TECHNICAL BULLETIN GE-35/TR-22

DATE: JANUARY 17, 2006
MODEL YEAR: 2005 & AFTER
TRANSMISSION: MLS63B MANUAL TRANSMISSION
CHASSIS MODEL: UD1800HD ~ UD3300
BULLETIN NUMBER: GE-35/TR-22
FILE IN THE GENERAL AND TRANSMISSION SECTIONS OF THE TECHNICAL BULLETIN BINDER

MLS63B COUNTERSHAFT END PLAY CLARIFICATION

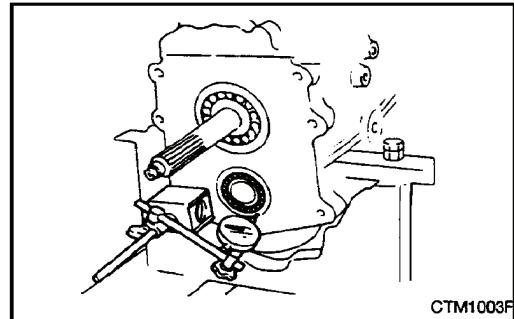
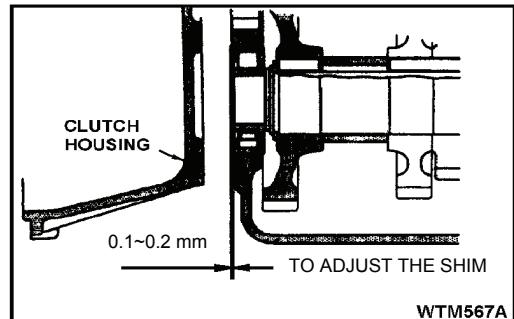
The 2005 & 2006 UD Trucks Service Manual CD's utilize the incorrect wording for the MLS63B countershaft end play measurements and adjustment procedure.

This applies to the Chassis Section / Manual Transmission page TM 1-6-6 step #3 in the 2005 & 2006 UD Trucks Service Manual CD's.

When performing repairs to the MLS63B transmission, the reassembly procedure step #3 should read as follows:

3. Clutch housing assembly

Select shims and install so that they are recessed below the transmission case end surface by 0.1 to 0.2 mm (0.004 to 0.008 in). The thicknesses of the shims are 0.1, 0.2 and 0.3 mm (0.004, 0.008 and 0.012 in)

NOTE: The countershaft end play has increased in the 2005 MY with the introduction of the MLS63B transmission and the J08-TE engine.
